City of Chicago
Richard M. Daley, Mayor
Department of Transportation

January 19, 2011

Re: Navy Pier Flyover Project

Figure 1

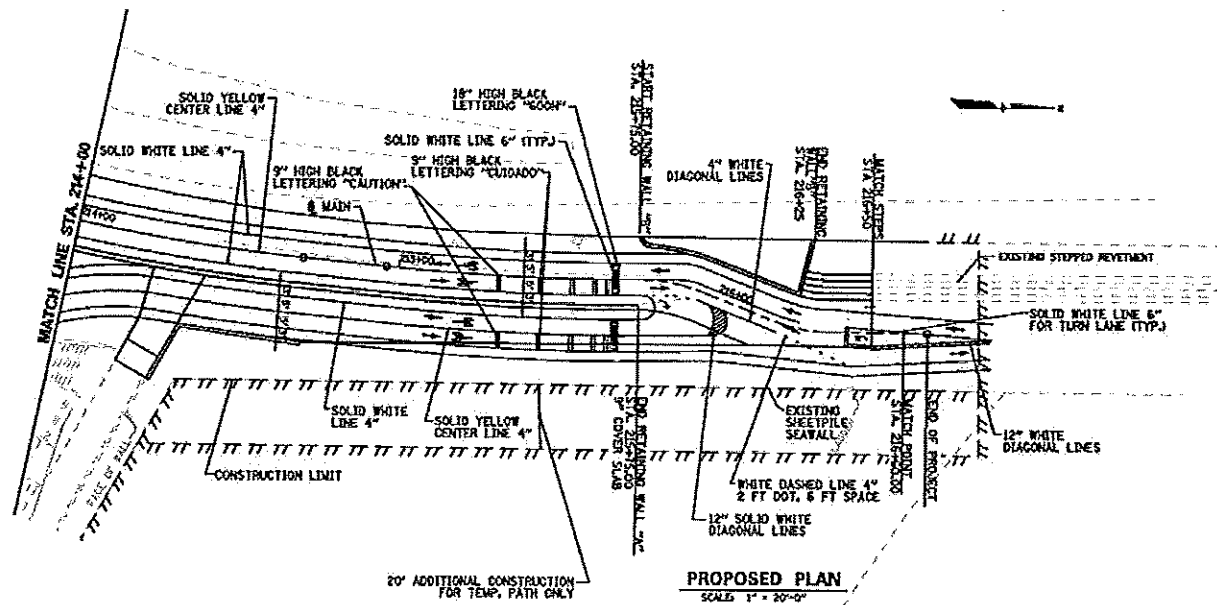
- *Provide clarification on the north end bifurcation and how the flyover will look and interact with the existing area and the path leading to the Ohio Street Beach.*

Figure 1 below illustrates the bifurcation at the north end of the flyover at the Ohio Street Beach area. Existing paths and accesses to Jane Addams and Ohio Street Beach will be maintained. Note the southern end of the existing stepped revetment and the proximity of the path rising up (west of embankment wall – top two lanes on exhibit). The line that divides the rising path and the ground-level lanes is labeled “End of Retaining Wall A.” The intent is for the path to hug existing Lake Shore Drive and thereby occupy as little space as possible and have as little impact as possible on existing conditions.

Figure 2

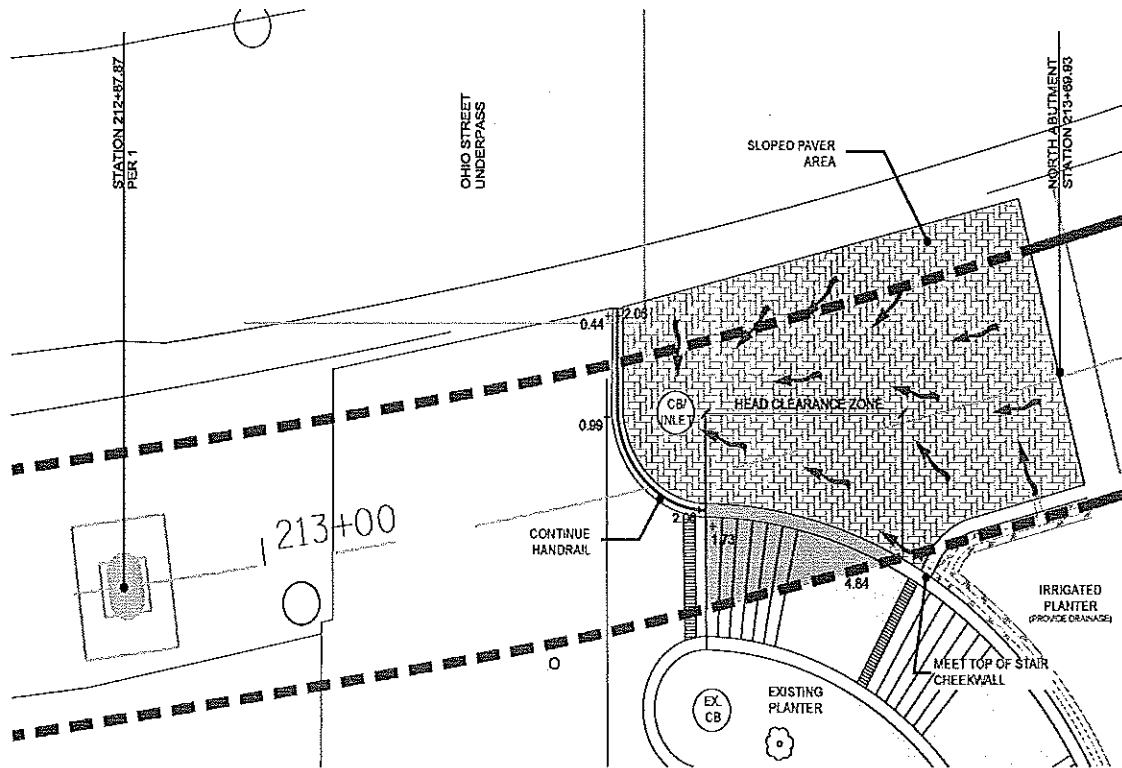
- Provide a specific design and use for the plaza area south of the Ohio Street underpass.

The City continues to coordinate with the Chicago Park District to determine a safe and secure way to program the space within the plaza area (see Figure 2). Although a final decision has not been reached at this point, some example uses being discussed include bike parking and a secure Park District space for equipment. CDOT understands the importance of securing this space and programming it in a positive and useful way.

Figure 4

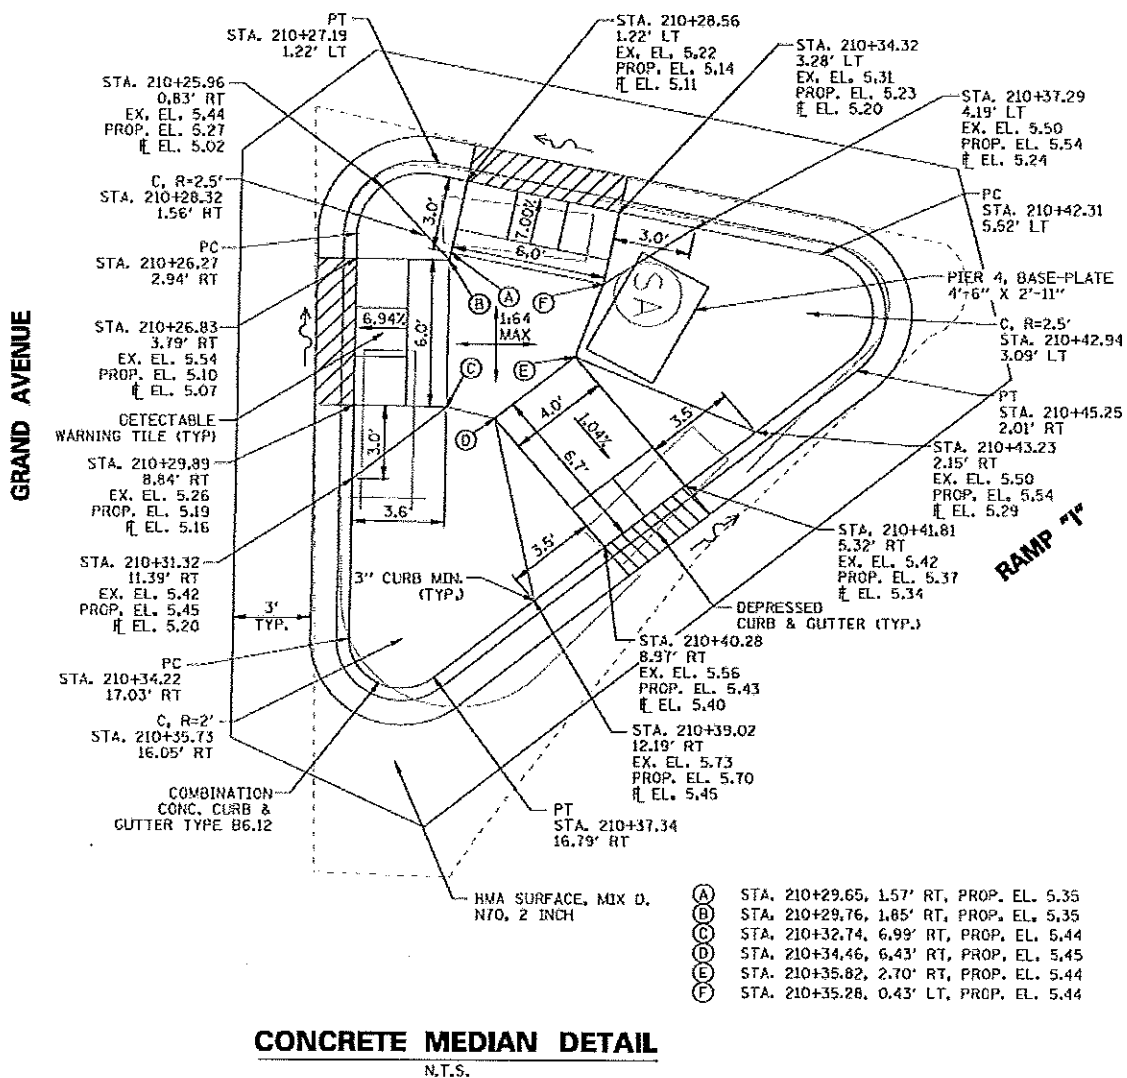
- Address concern about small island at Grand and the northbound Lake Shore Drive ramp intersection.

Figure 4 shows the current plan for the island formed by edges of Grand and the access to the northbound Lake Shore Drive ramp from Grand and northbound lower level Lake Shore Drive. Although the space defined within these three roads is small, ADA requirements are met and the new column and existing traffic pole can be accommodated. While the Grand Avenue crossing will be improved, one of the major goals of the Flyover is to divert at-grade traffic away from this intersection and either guide users to the Flyover or through Jane Addams Park to Navy Pier. CDOT is also providing extensive wayfinding to minimize foot traffic across this island.

Figure 5

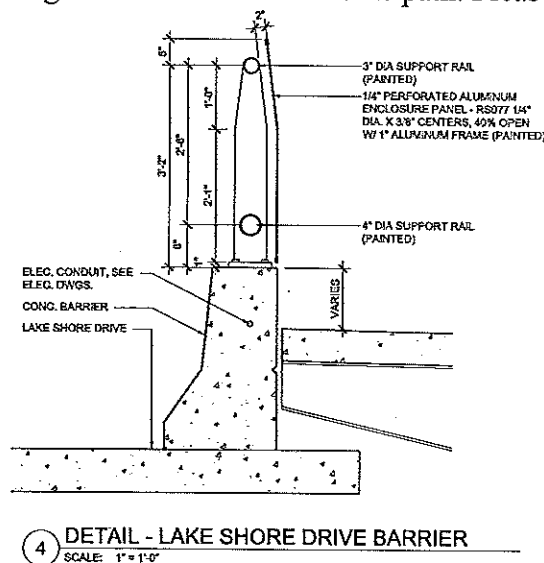
- Address maintenance of areas along the lakefront, where responsibility is shared among many entities, as well as the plans for the maintenance of the flyover itself.
- Confirm that the sidewalk along the east side of lower Lake Shore Drive between Grand Avenue and the junction of the flyover near the Chicago River Bridge will continue to be maintained by CDOT.
- Address the concern about snow removal, especially in areas where CDOT snowplows clearing upper Lake Shore Drive push snow onto the flyover following path clearance.

Roadway and sidewalks currently under CDOT’s care will continue to be maintained by CDOT. The City will also continue to remove snow from the roadways and work with the Park District to determine the best plan to remove snow from the Lakefront Trail. As with the rest of the Lakefront Trail, the Park District will be able to use their equipment to access the Flyover to provide required maintenance, such as sweeping or snow removal. To help protect the path from snow and water, a screen wall, which will vary from 4.5 to 5 feet in height, will be placed on the required barrier wall separating LSD traffic from the bike path. Please see Figure 5 below.
